Under the **FAST-TRACK APPROVALS ACT 2024**
In the matter of an application for resource consents, concessions, wildlife approvals, an archaeological authority, and approvals relating to complex freshwater fisheries activities in relation to the Southland Wind Farm project

By **CONTACT ENERGY LIMITED**
Applicant

**MEMORANDUM OF COUNSEL FOR CONTACT ENERGY LIMITED
IN RESPONSE TO MINUTE 3 OF THE EXPERT PANEL**

12 December 2025

Figure 1: Locations of visual simulations prepared at private residences

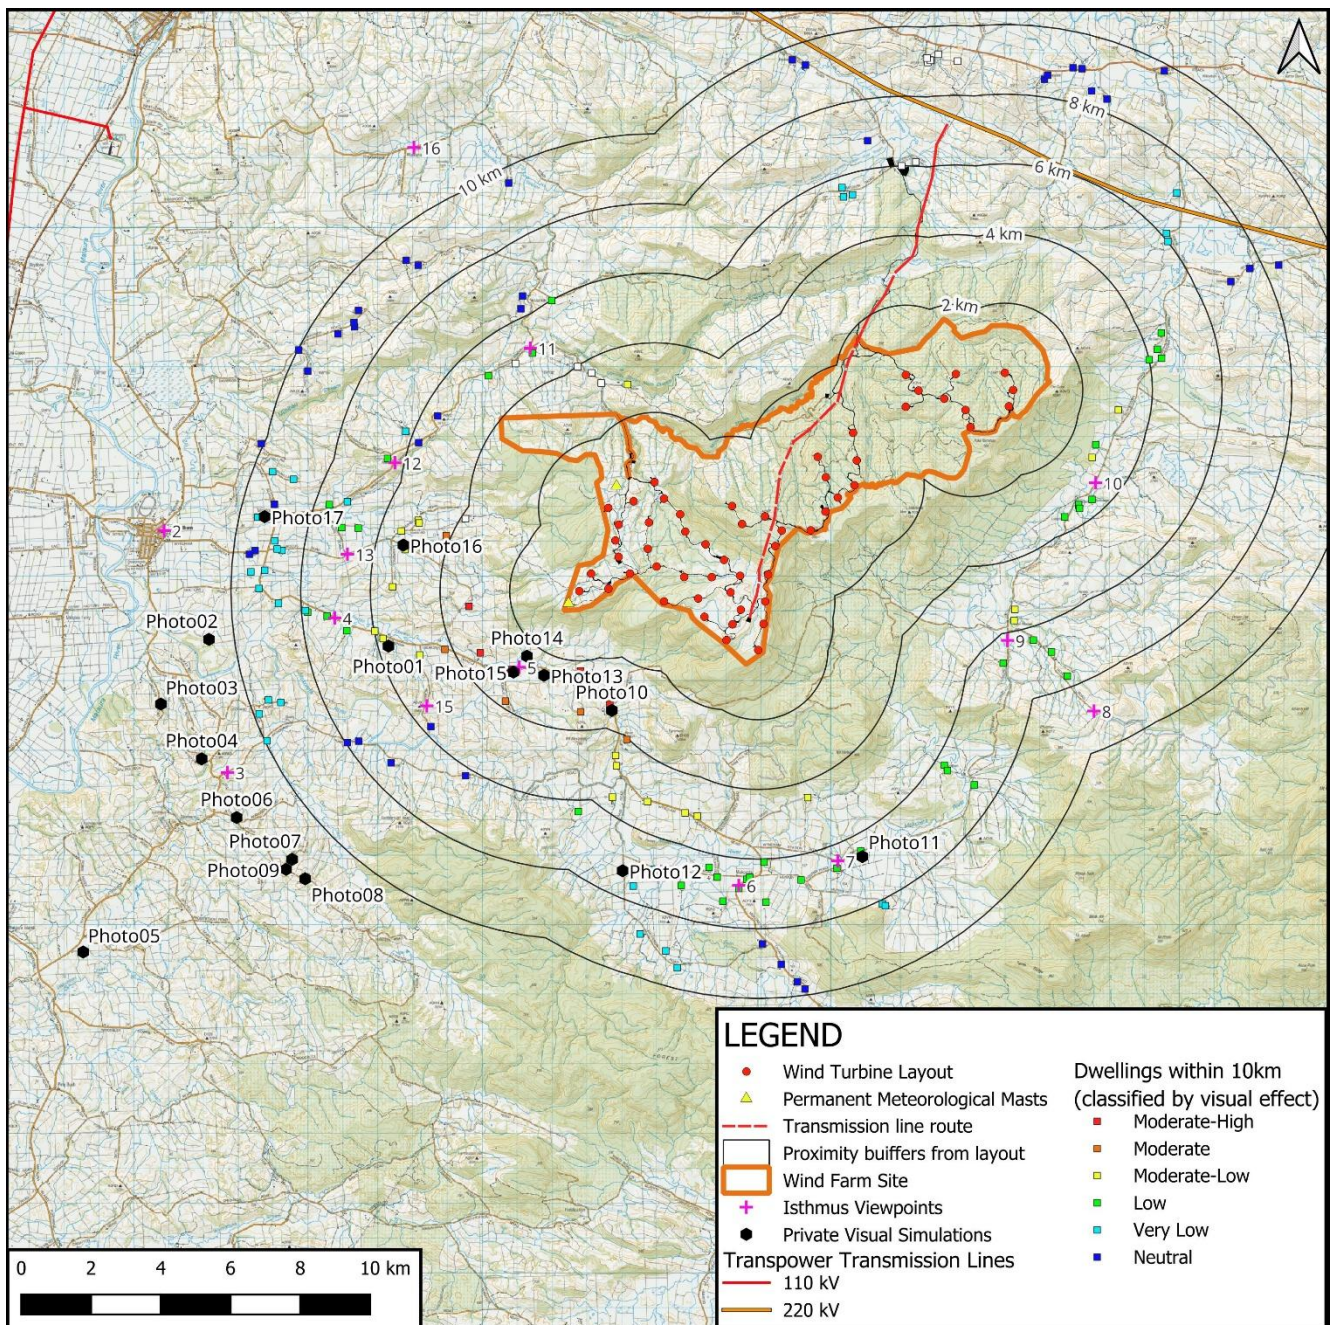
8. The Panel has asked Mr Coombs to consider and advise:

"a. What residences have been visited, as opposed to being assessed on a desktop basis; and

- (a) At the request of Te Ao Marama Incorporated, Isthmus visited and took photographs from four viewpoints relevant to the local Rūnaka, namely the marae at Awarua, Waihōpai, and Hokonui and the summit of Motupōhue/Bluff Hill. Where the wind farm would be visible from these locations, a visual simulation was prepared.
- (b) Contact was also asked to prepare visual simulations from 17 private properties.³ Those visits were undertaken by Paul Botha of Roaring 40s, who took the relevant photographs, prepared the simulations, and provided them to landowners and to Isthmus to assist in its visual assessment. The 17 locations visited are illustrated in **Figure 1 below**, numbered Photo01 to Photo17. Please note that:

- (i) A visual simulation was ultimately not prepared from the location marked Photo5, because the digital terrain model did not extend to that location (over 15km from the nearest Project wind turbine).
- (ii) Simulations were prepared from the other 16 locations and provided to the relevant landowners.
- (iii) In around 10 cases the relevant photographs were taken near the dwelling on the property. In six other cases, simulations were prepared at some distance (in one case, 900m) from the dwelling, in order to have a clearer view of the Project.
- (iv) Further details regarding each photograph location, including the coordinates, view direction, field of view, and elevation, are available if those would assist the Panel.

Figure 2: Pasture to plantation forestry conversions since mid-2023

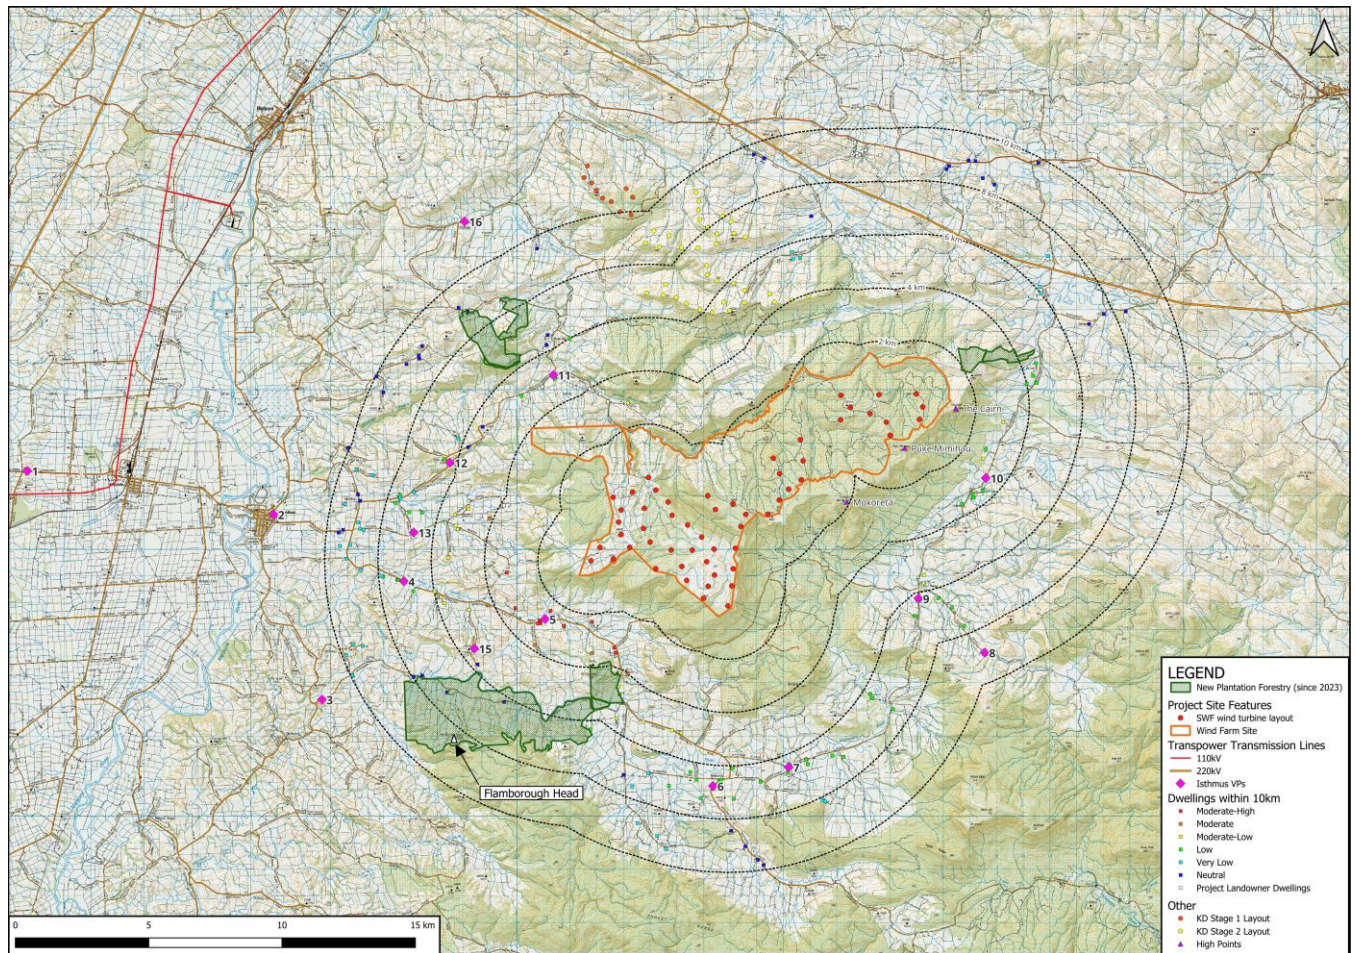
b. Any material changes, in terms of the existing land-use environment, since his Figure Set was compiled."

17. Contact is aware of over 1500ha of new plantation forest having been planted in areas that were previously pasture within 10km of the Project, since mid-2023 (i.e. in the period after the simulations were prepared), as shown in dark green hatching in **Figure 2 below**.

18. By reference to the Figure Set, these changes are likely to be discernible (and will become more visible over time as the trees grow) in the following locations:

- (a) From **VP1**, the two new areas of forestry northwest and southwest of the Project site may become visible after a number of years as the trees grow (although they are at some distance from the viewpoint location).

- (b) From **VP3**, the large new forestry block to the southwest of the Project site will appear in the right-hand side of the view, in the area between Mt Herbert and Flamborough Head. This is to the right of the Project

- (c) From **VP6**, the large new forestry block to the southwest of the Project site will appear on the left when looking towards the Project from this location.

- (d) From **VP7**, the large new forestry block to the southwest of the Project site will appear on the left, in the distance, beyond the end of Wyndham Station Road after the trees have grown.

- (e) From **VP10**, the new forestry block to the east of the Project site may appear to the right of the wind farm in the distance along the alignment of Slopedown Road.

- (f) From **VP12**, the large new forestry block to the southwest of the Project site will appear in the area between the Project site and Flamborough Head.

- (g) From **VP16**, as the forest in the block to the northwest of the Project site matures, it may become visible above the land in the foreground.
 - (h) From **VP15**, the large new forestry block to the southwest of the Project site will appear in the area between the Project site and Flamborough Head on the right.
